# STATEMENT OF ENVIRONMENTAL EFFECTS

MODIFICATION OF DA17/1247 – PLACE OF PUBLIC WORSHIP

230-242 ALDINGTON ROAD, KEMPS CREEK

APRIL 2020

Figure 3 South elevation showing approved building outline (blue) and proposed amendment

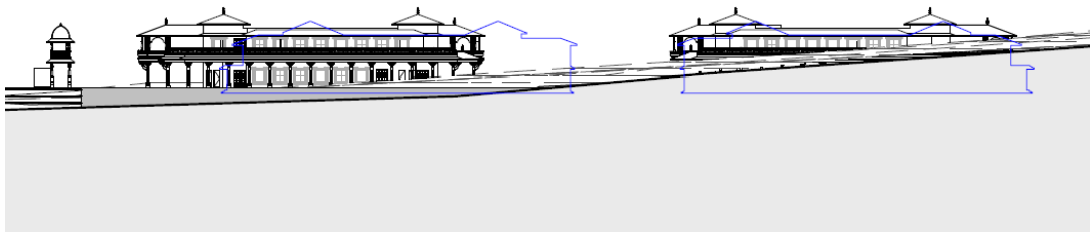
- The proposed modifications are in level of the building and building pad made whilst maintaining a balance of cut and fill (ie no excess material required to be removed from site).
- Please see attached statement from Wood and Grieve Engineers regarding this.
- The level of the site pad for the Central Building has increased by 0.840m (from RL60.400 to RL61.240) increasing site efficiency, amenity and safety.
- Increase to the height of the Central Building of 1.07m (from RL71.103 to RL72.171) to facilitate appropriate clearances for the Sabha Hall, Dining and Kitchens based on required construction and structural clearances.
- The Mandir site pad level remains unchanged from the approved DA.

- The Sabha Hall building has moved in a westerly direction towards the street 12.5m.
- The Dining Hall building has moved in a westerly direction towards the street 2.5m.
